Accessibility Assessment Report

**Project Address: Tower B One Circular Quay,
1 Alfred St Sydney NSW 2000**

Report Number: 152779

Revision: 07 S4.55

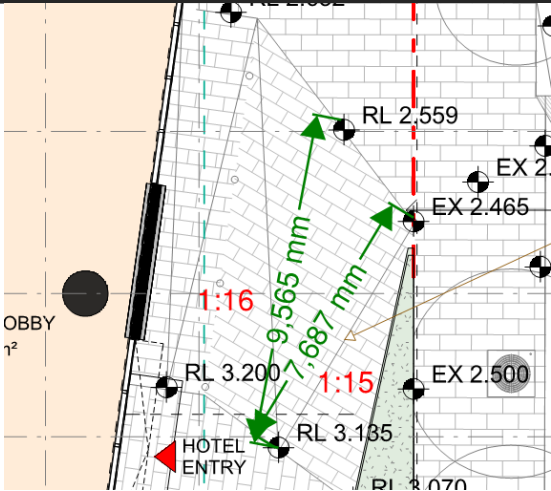
D3.11	Ramps	<p>A series of connected ramps must not have a combined vertical rise of more than 3.6m.</p> <p>A landing for a step ramp must not overlap a landing for another step ramp or ramp.</p> <p>The following requires design modification or a performance-based approach:</p> <ul style="list-style-type: none"> ▪ The BoH step ramp at ground floor level has an overlapping landing with a second step ramp. Design modification required at construction certificate or pursue a performance-based approach. Refer to Figure 5 below. 	Performance Solution

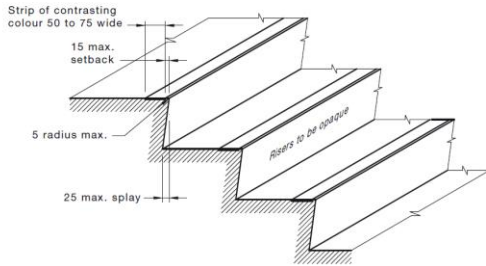
10.2	Walkways	<p>A walkway is proposed from Alfred / Pitt Street to the hotel lobby to address the proposed level change.</p> <p>The following requires design modification at construction certificate:</p> <ul style="list-style-type: none"> ▪ The proposed walkway from Alfred / Pitt Street has a proposed gradient of 1:15 – 1:16 which is not in accordance with the maximum gradient of 1:20 permitted for a walkway in accordance with AS 1428.1-2009. Refer to Figure 7 below. 	Design modification required

1428.1 Clause	Title	Assessment and Comment	Status
		 <p><i>Figure 7 – Proposed walkway from Alfred / Pitt St to hotel lobby</i></p> <p>One of the following is to be provided at walkways:</p> <ul style="list-style-type: none"> ▪ The ground surface abutting the walkways shall be firm and level, follow the grade of the walkway, be of a different material and extend a minimum of 600mm; or ▪ Kerb with a minimum height of 65mm; or ▪ Kerb rail and handrail; or ▪ A wall with a height of not less than 450mm. <p>Landings are not required where the walkways are shallower than a 1:33 gradient.</p> <p>Construction documentation should demonstrate compliance.</p>

Figure 10 – Hotel lobby handrail extension setback required

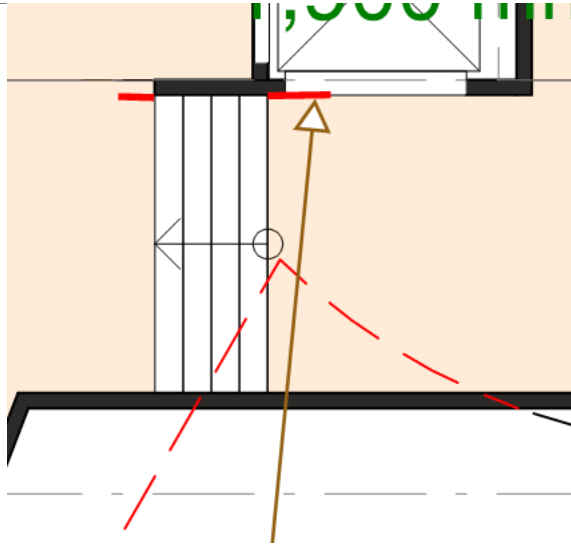
1428.1 Clause	Title	Assessment and Comment	Status
		<p>and TGSIs do not protrude into the traverse path of travel.</p> <p>At an intersection within an internal corridor stairway to be setback a minimum of one tread width + 300mm + handrail return to ensure handrails and TGSIs to not protrude into the traverse path of travel.</p> <p>Stairways are required to have opaque risers and nosings with a contrasting strip not less than 50mm nor more than 75mm in depth, set back a maximum of 15mm from the front of the nosing. Where the contrasting strip is not set back from the front of the nosing then the area of contrast must not extend down the riser by more than 10mm.</p>  <p>NOTE: A chamfered nosing 5 x 5 mm may be used.</p> <p><i>Figure 9</i></p> <p>The following stairways will require review at construction certificate stage to ensure there is sufficient space for compliant handrails:</p> <ul style="list-style-type: none"> ▪ The stairway connecting the Hotel Lobby to the George Street entrance does not have a sufficient setback to provide handrails compliant with AS 1428.1-2009. Refer to Figure 10 below:

Figure 11 – Ground floor stairway from Pitt St

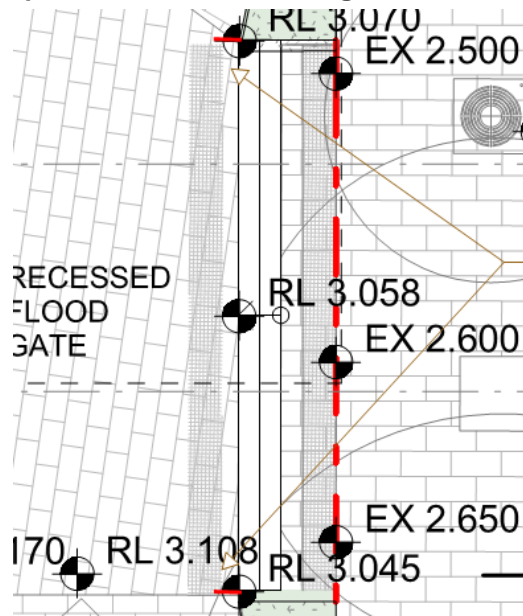
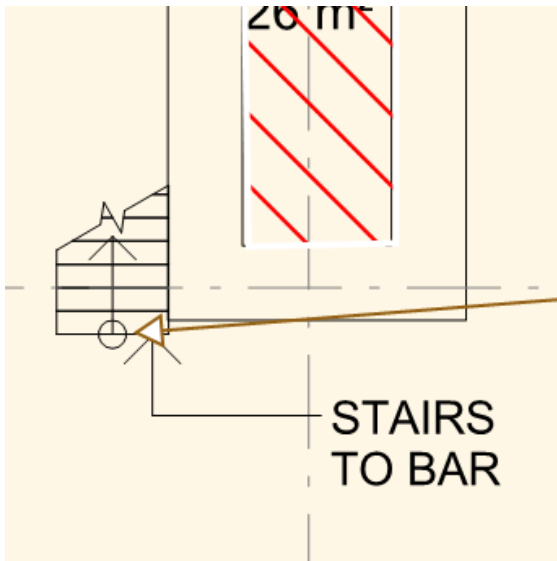
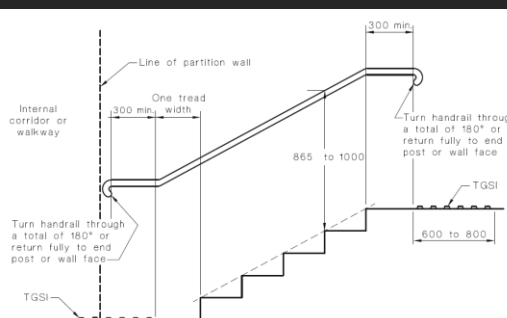
- Stairway setback will require review at the Hotel entrance stairway via Pitt St as handrails will protrude into the transverse path of travel. Refer to Figure 11 below.

Figure 14 – Residential storage latch side clearance

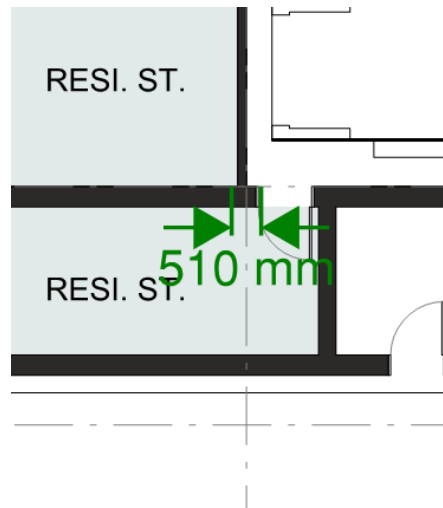
13.3	Circulation spaces at doorways	<p>Circulation spaces are required to be provided on both sides of every door on an accessible path of travel.</p> <p>Where swing doors are automated and have a side approach – circulation space is required on the approach side only.</p> <p>In addition to the non-compliances identified in Clause 13.2 above, the following doorways do not comply with circulation requirements and require modification at construction certificate stage:</p> <ul style="list-style-type: none"> ▪ Residential storage at basement 4&5 (south) – ensure latch side clearance away from user is in accordance with AS 1428.1-2009. Refer to Figure 14 below 	Design Modification Required Performance based approach

Figure 15 – Residential bicycle store latch side clearance

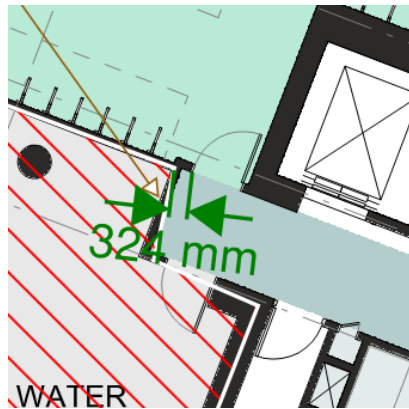
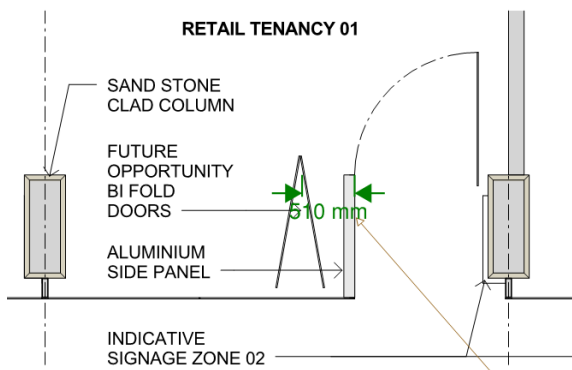
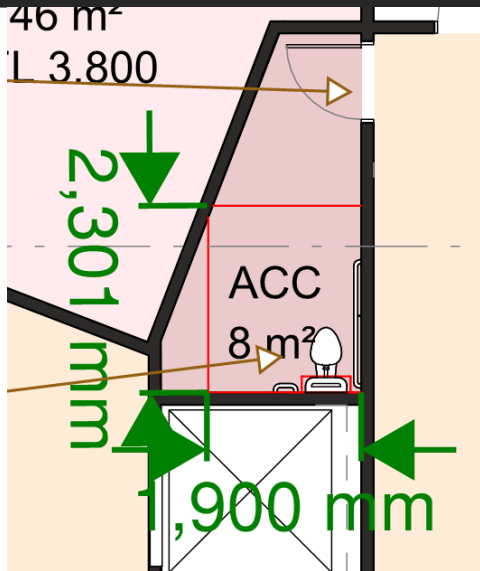
- Ensure door to residential bicycle store at Basement 02 has a minimum latch side clearance of 510mm away from user. Refer to Figure 15 below
